Addendum #2

Date: December 17, 2025

Subject: Addendum #2
H&P Project # 2025087
Seneca Park Phase 1 Water & Sewer
Campbell County, VA

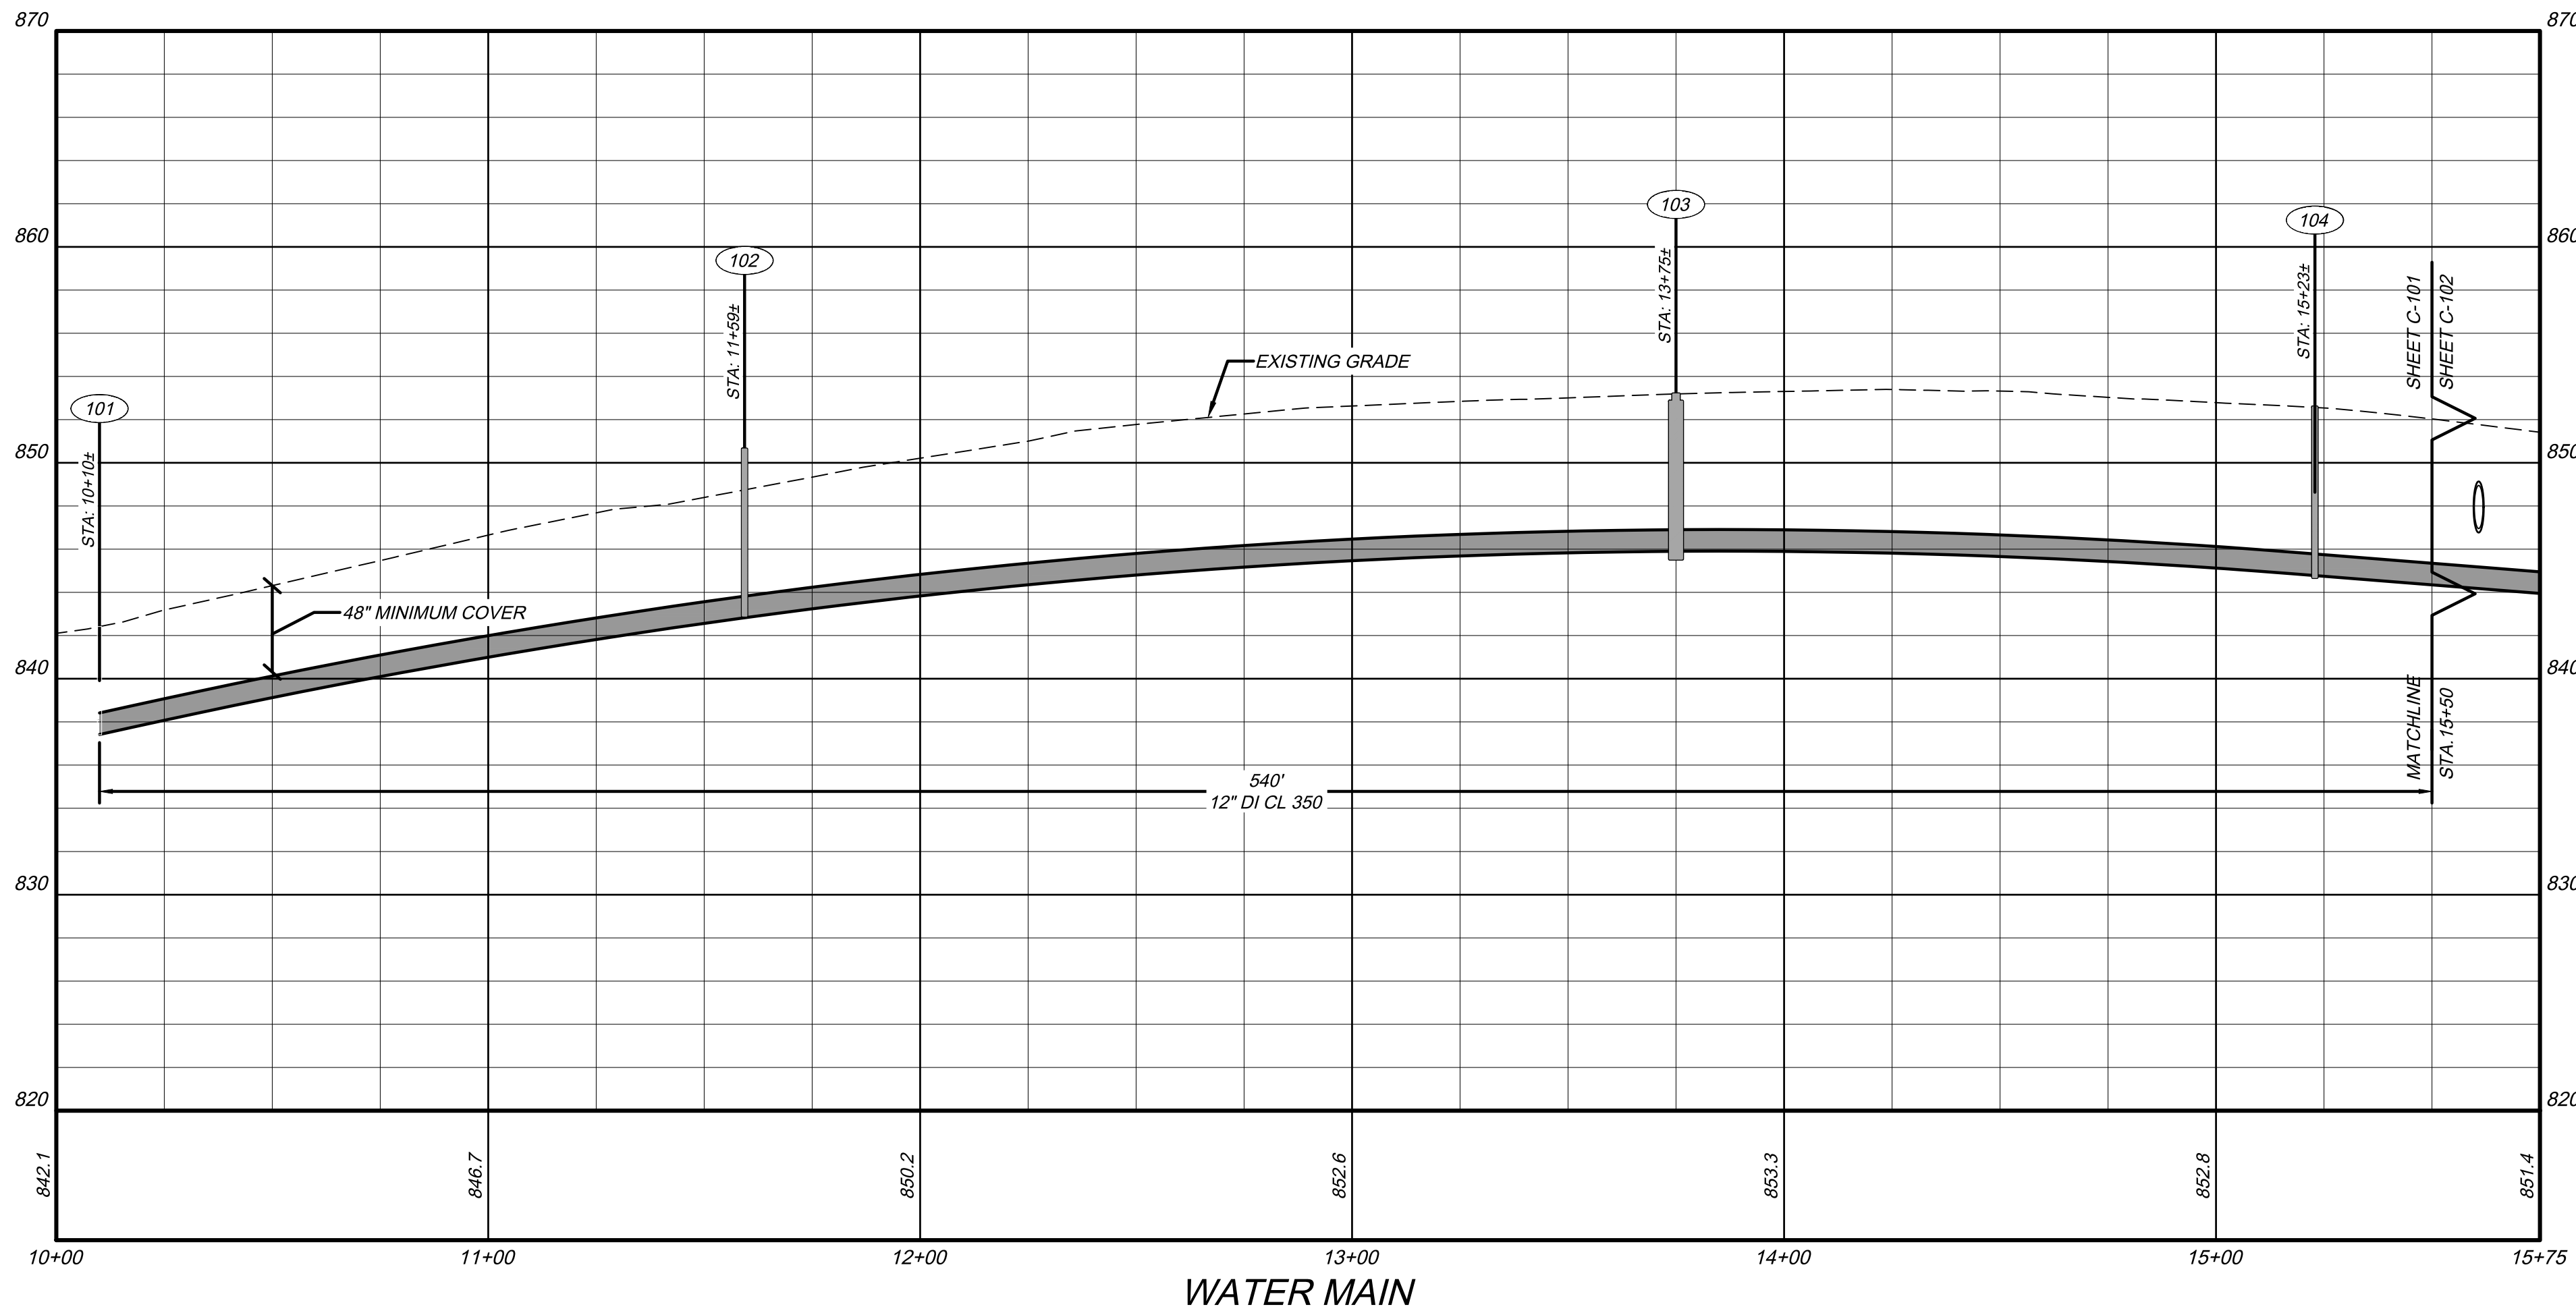
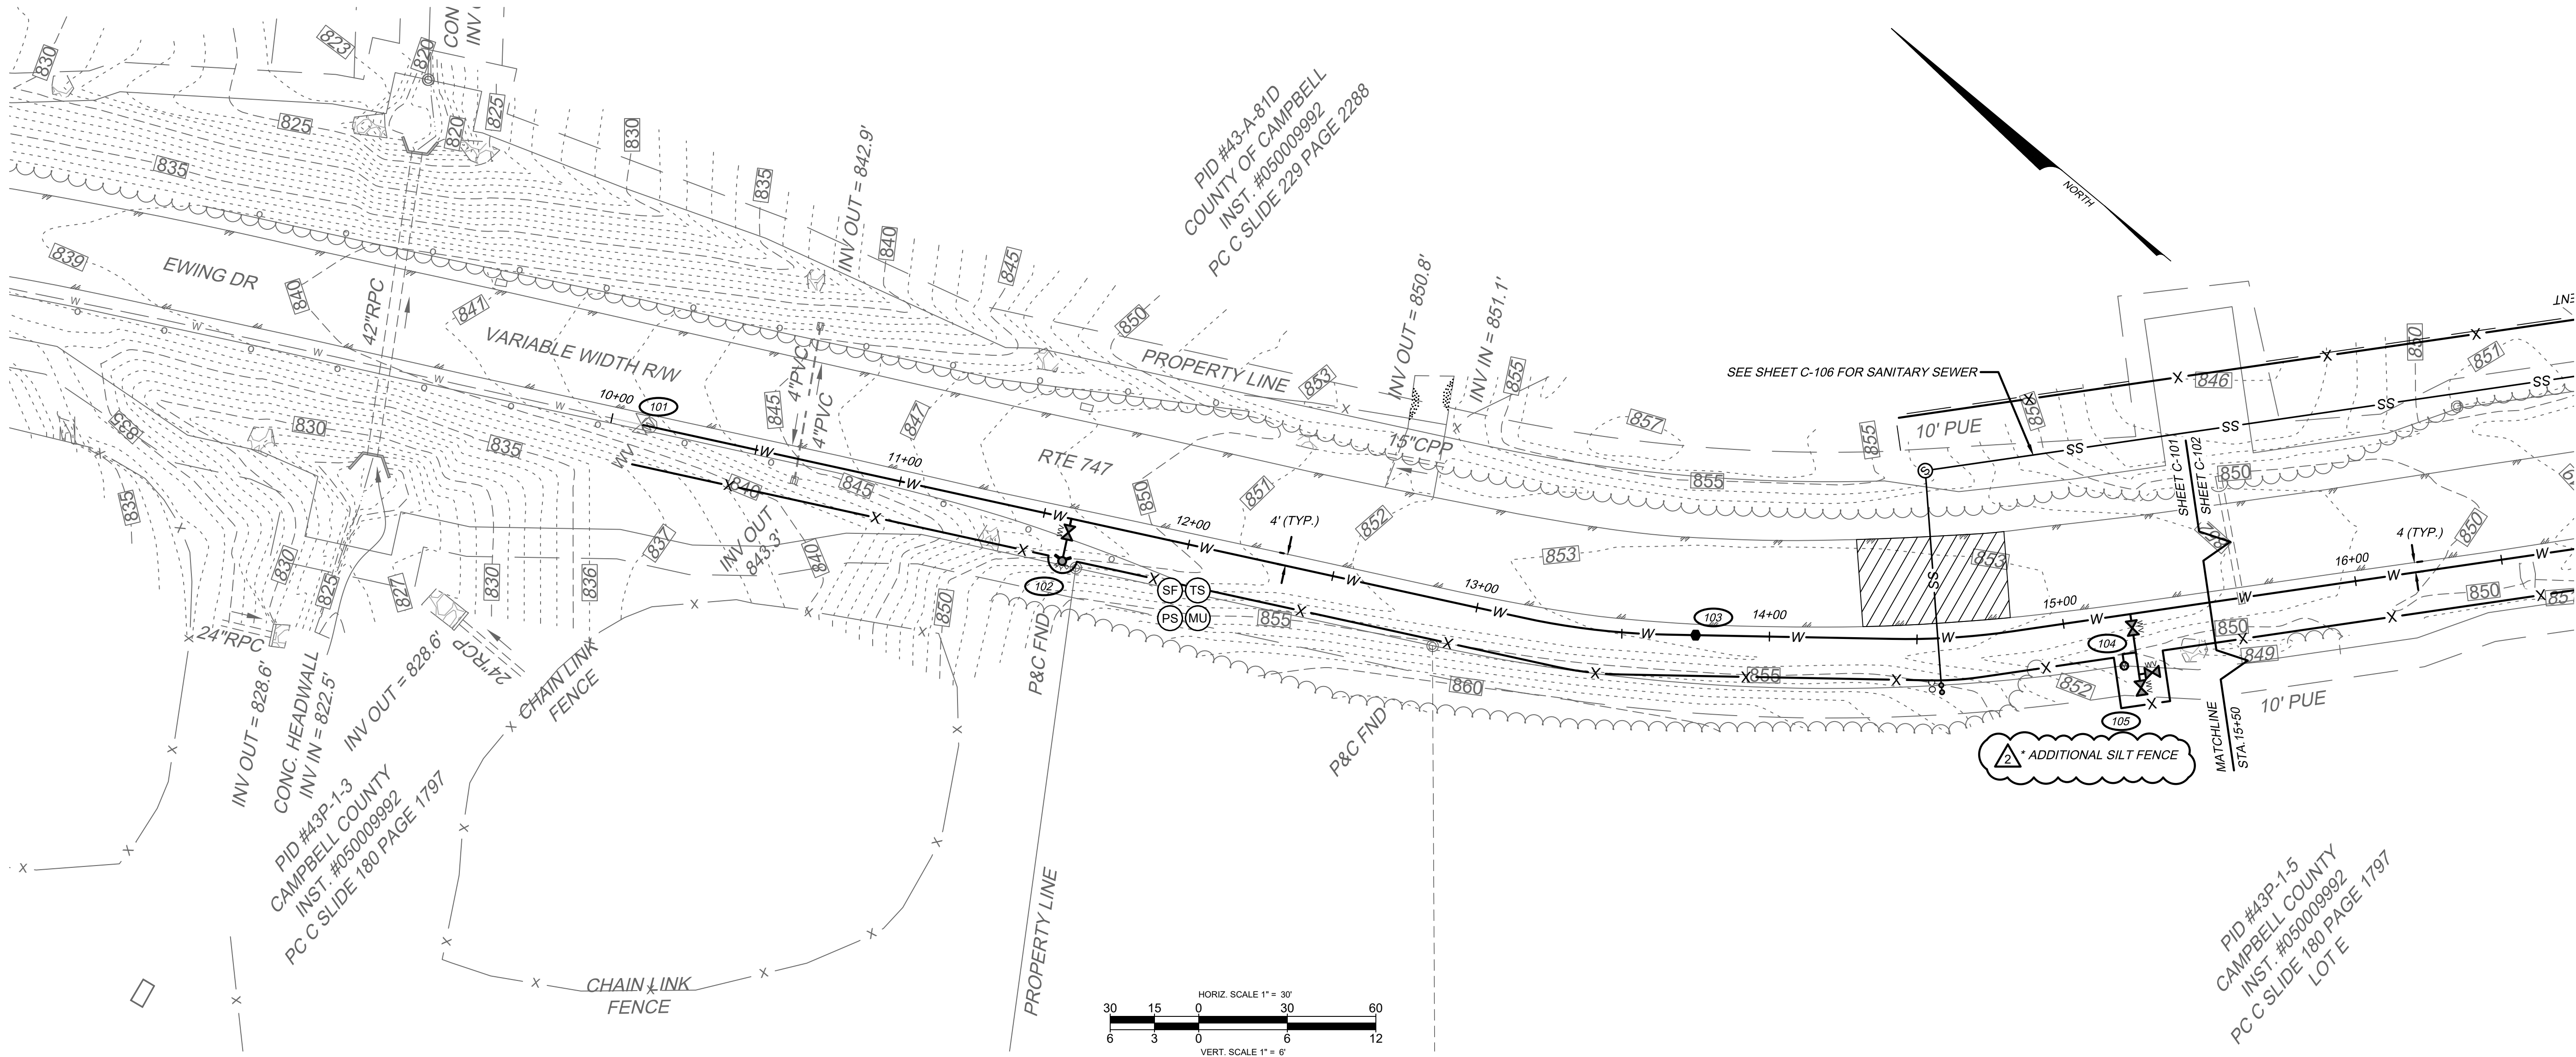
Item Ten: Silt Fence

Silt fence lengths have been updated on the plans based on County comments. The updated quantity has been revised on the bid form.

Updated plan and profile sheets will be included with this Addendum to show the added silt fence and updated water line structure. All changes will be clouded.
